Optical Modulation Amplitude (OMA) for single-mode serial PMDs

Peter Öhlen, Krister Fröjdh, OptoTronic
Piers Dawe, Agilent
Mark Donhowe, WL Gore

What is OMA ?

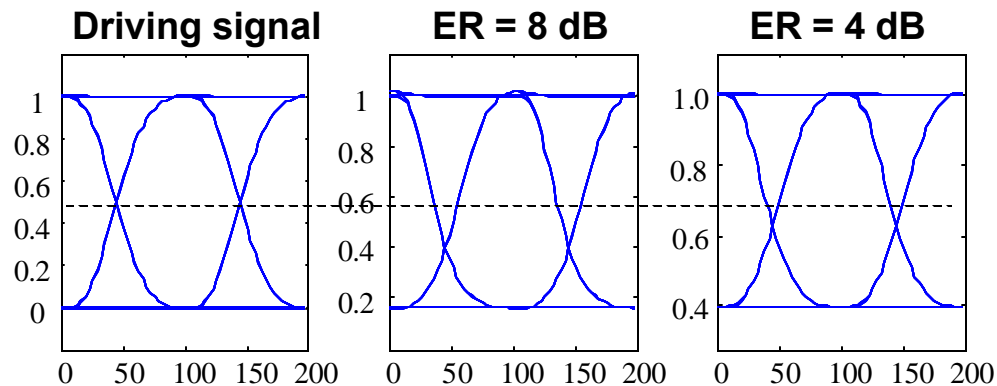
- Used by FC
- At high ER:
 $\text{OMA} / 2 = P_{\text{average}}$
- Measurements are somewhat different
 - Changes in 52.6
- You could measure
 - P_{average} & ER
 - and calculate OMA
